RECEIPT DATE: 2-8-18 **ONSITE SEWAGE DISPOSAL SYSTEM** P 562422

PROPERTY ADDRESS: 1015 Fairlane Road

SUBDIVISION: Fairlane Farms LOT: 16 TAX ID: _____

SEPTIC SYSTEM
 INSTALLATION SITE PLAN
 LOT 16
 1015 FAIRLANE ROAD
 FAIRLANE FARMS
 PHASE ONE
 ZONED: RC-DEO

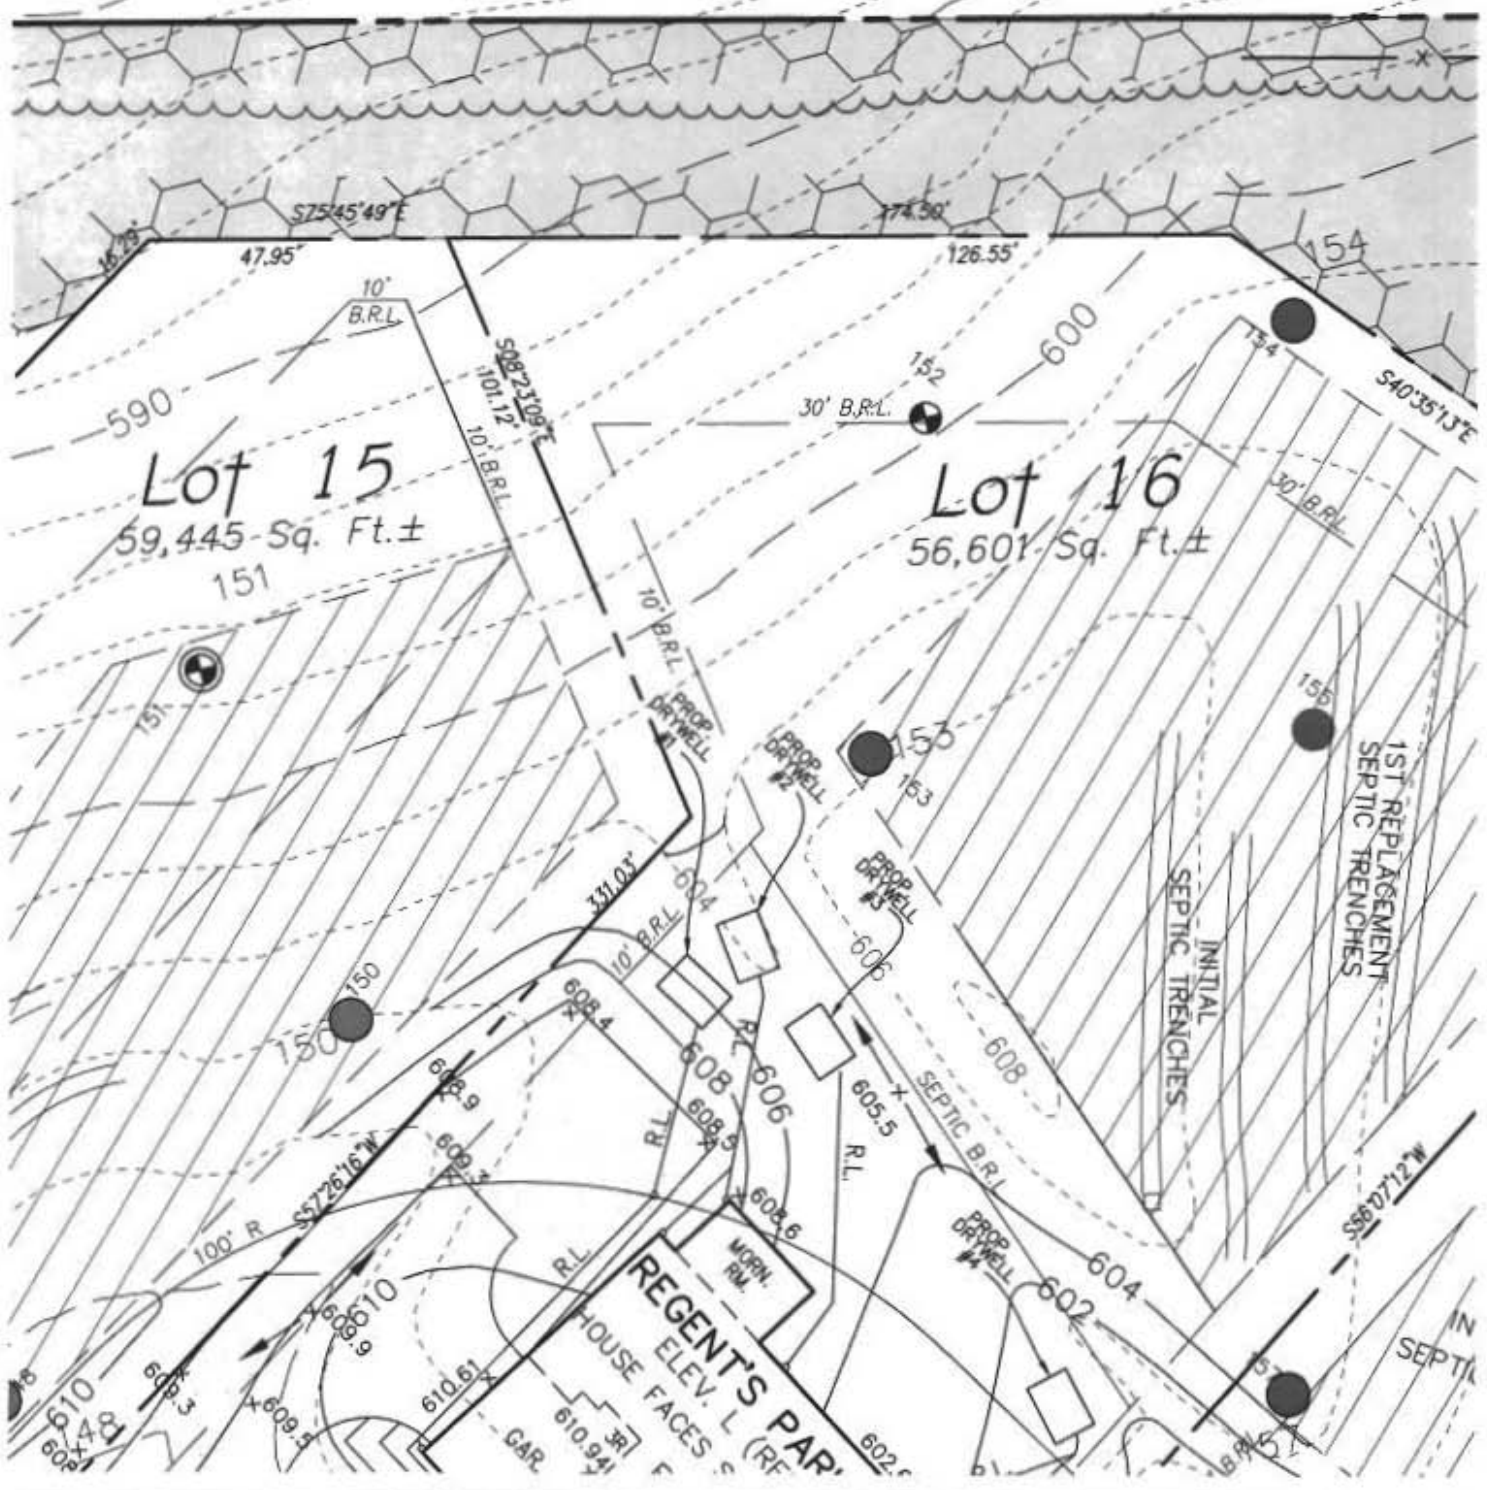
- ✓1.) Septic tank is less than 25 feet from the nearest storm water management drywell. The setback requirement is 25 feet.
- ✗ 2.) Septic profile shows invert into septic tank is greater than invert out of cleanout.
- ✓3.) 1st replacement coefficient calculation number should be 2 (not 1)
- ✗ 4.) 2nd replacement effective depth equals 0 therefore no sidewall reduction
- ✓5.) 1st replacement trench layout shows longer than 65.10 feet of trench
- ✓6.) Trench data elevations shows 7 foot trench depths (should be 6 feet)

HOUSE LOCATION DRAWING

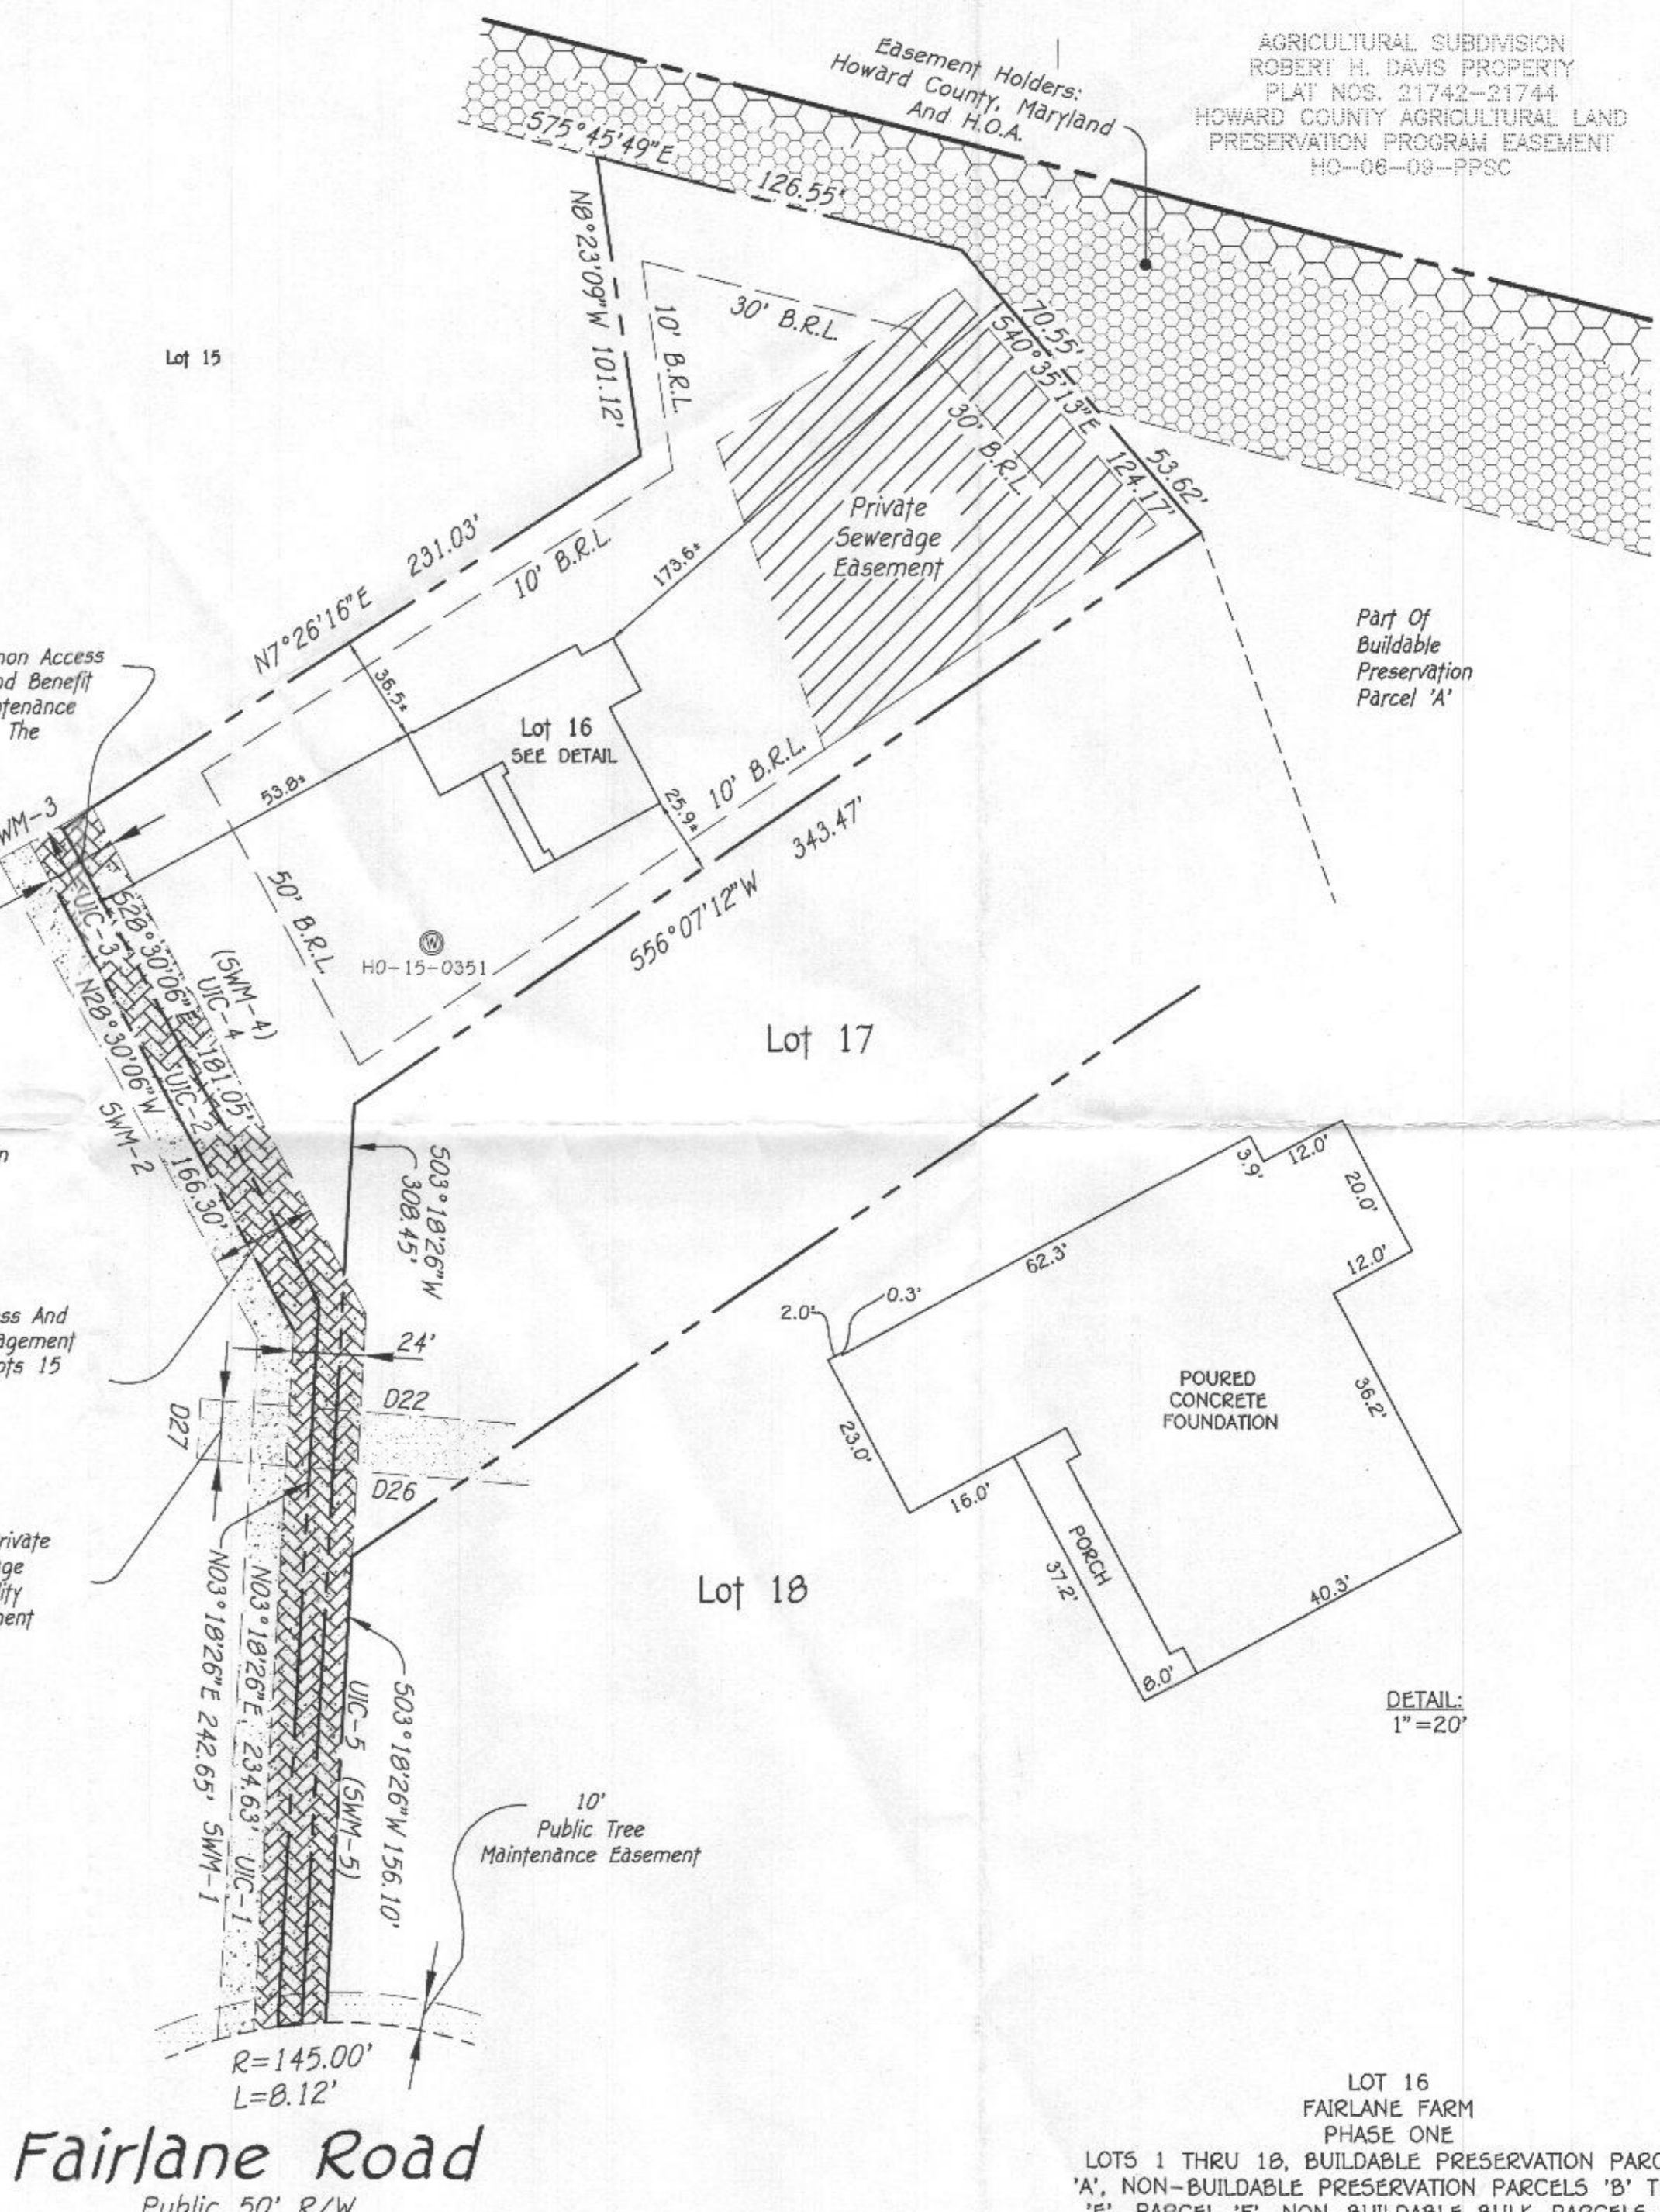
I was at 1015 Fairlane Rd today for the layout of the septic system. The contractor and I shot some elevations in the field and it appears that the line will not make fall to a 3' inlet at the trenches. From what I calculated, the inlet at the trenches would be 4.5'+. Here are our measurements:

70" at the house where the line comes out, top of pipe (slightly different location than shown on the plan- 1' left of the bumpout)

57" at the approximate location of the tank

27" at the approximate location of the distribution box

We figured out that there is enough room to turn the tank 90 degrees and fit in a pump tank to make the 3' inlet. If the inlet is deeper than 3', the length of the trenches in the initial system needs to be increased as sidewall credit would be reduced.

Also, Perc 153 had a hard bottom at 7', so I'm planning to dig a test hole just above the proposed trenches to make sure we do not have a restrictive layer shallower than 10'. If shallower than 10', the bottom of the trenches needs to be raised to meet a 4' buffer.

Provided here are 3 copies new of a new Septic Installation Site Plan for Lot 16. (Since the plumber installed the exiting sewer pipe from the house contrary to the original plan's elevation & horizontal location, a pump tank will be needed (Sarah Collins is familiar with the situation). Please review this plan and if approvable as is, please leave 1 signed copy up front for us.
